CITY OF PLACERVILLE, CALIFORNIA
DEVELOPMENT SERVICES DEPARTMENT- ENGINEERING DIVISION

ADDENDUM

DATE: 10/12/15
PROJECT: BROADWAY CROSSWALKS IMPROVEMENT PROJECT
CONTRACT No: 41506
BID DATE: 10/27/15
ADDENDUM No: 1

Broadway Crosswalks Improvements Project
Curb Ramp Details No. 2

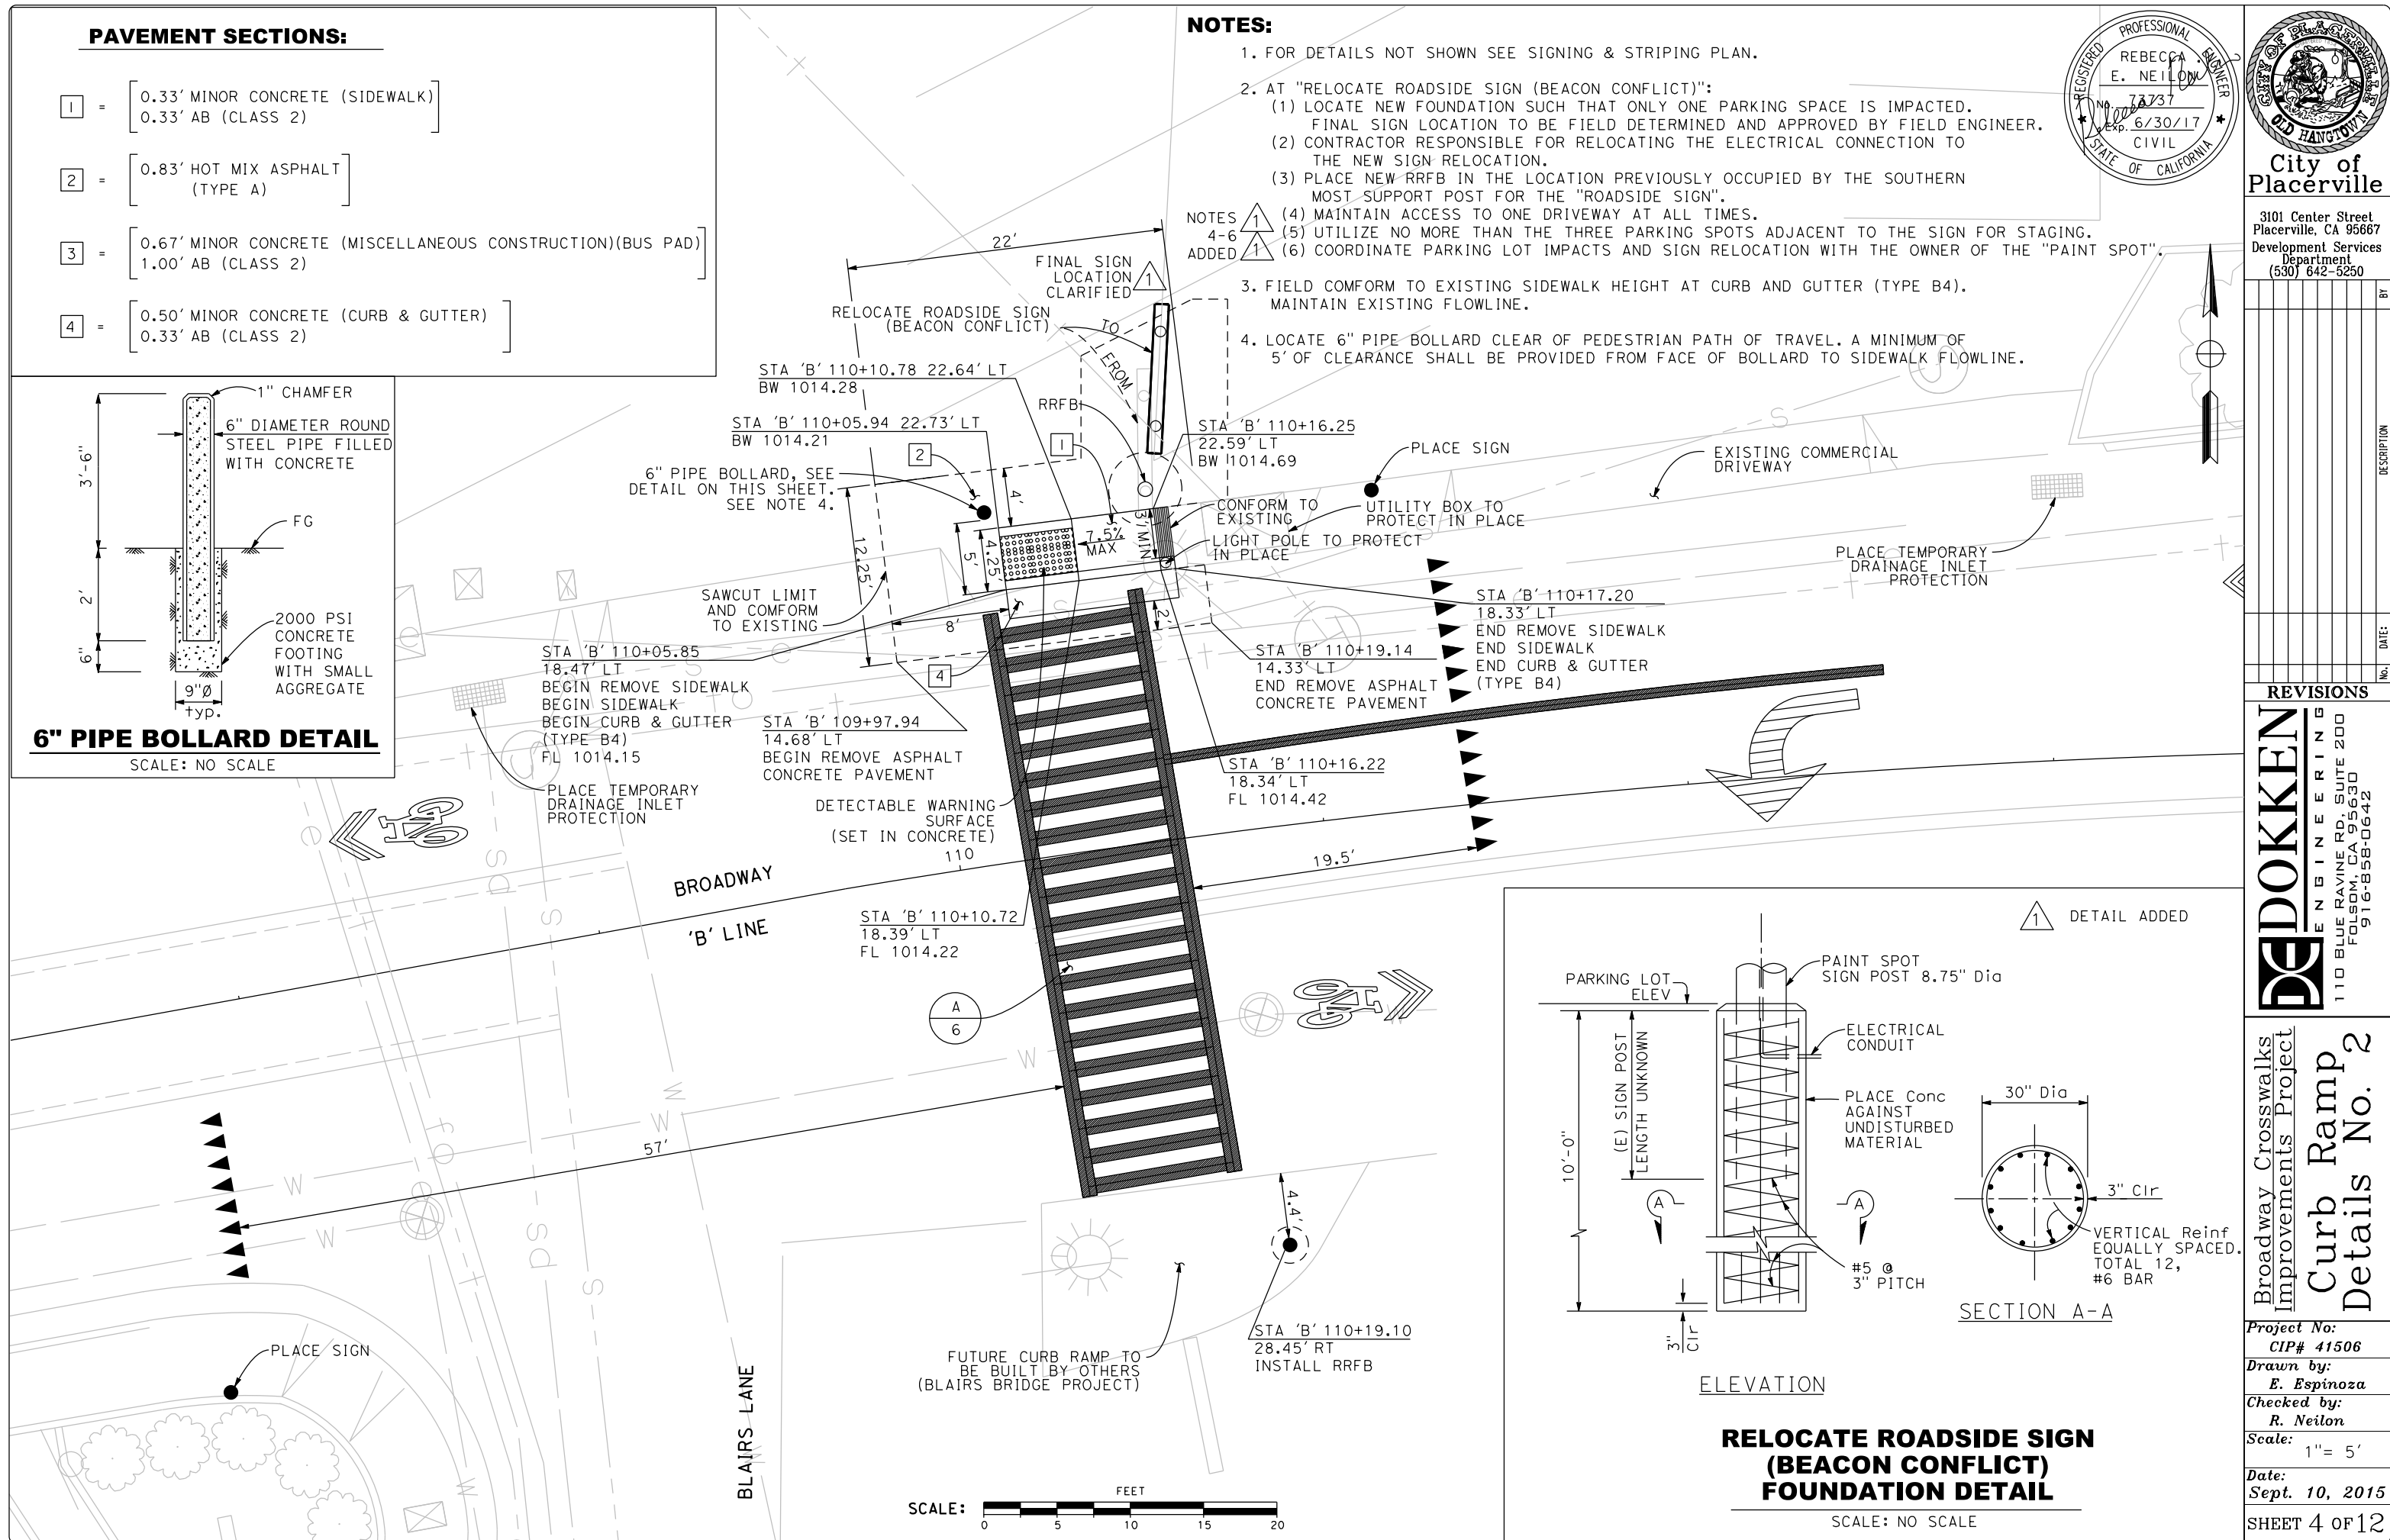
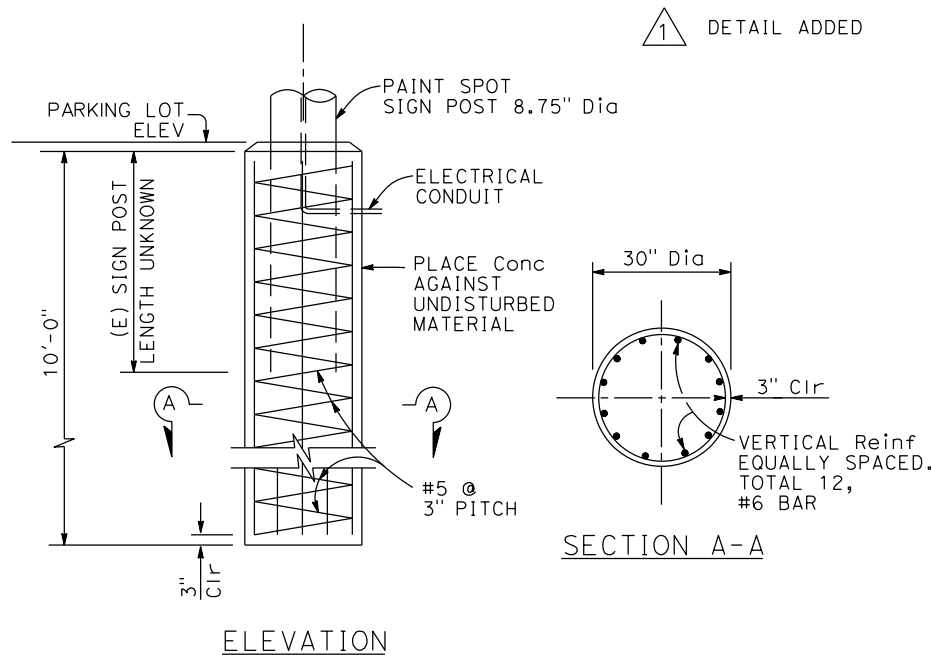
1. Plan Sheet 4 updated to clarify the work to be done with the Bid Item Relocate Roadside Sign (Beacon Conflict).

1. FOR DETAILS NOT SHOWN SEE SIGNING & STRIPING PLAN.
2. AT "RELOCATE ROADSIDE SIGN (BEACON CONFLICT)":
 - (1) LOCATE NEW FOUNDATION SUCH THAT ONLY ONE PARKING SPACE IS IMPACTED. FINAL SIGN LOCATION TO BE FIELD DETERMINED AND APPROVED BY FIELD ENGINEER.

- (2) CONTRACTOR RESPONSIBLE FOR RELOCATING THE ELECTRICAL CONNECTION TO THE NEW SIGN RELOCATION.
 - (3) PLACE NEW-RRFB IN THE LOCATION PREVIOUSLY OCCUPIED BY THE SOUTHERN MOST SUPPORT POST FOR THE "ROADSIDE SIGN".

- (4) MAINTAIN ACCESS TO ONE DRIVEWAY AT ALL TIMES.
 - (5) UTILIZE NO MORE THAN THE THREE PARKING SPOTS ADJACENT TO THE SIGN FOR STAGING.
 - (6) COORDINATE PARKING LOT IMPACTS AND SIGN RELOCATION WITH THE OWNER OF THE "PAINT SPOT".
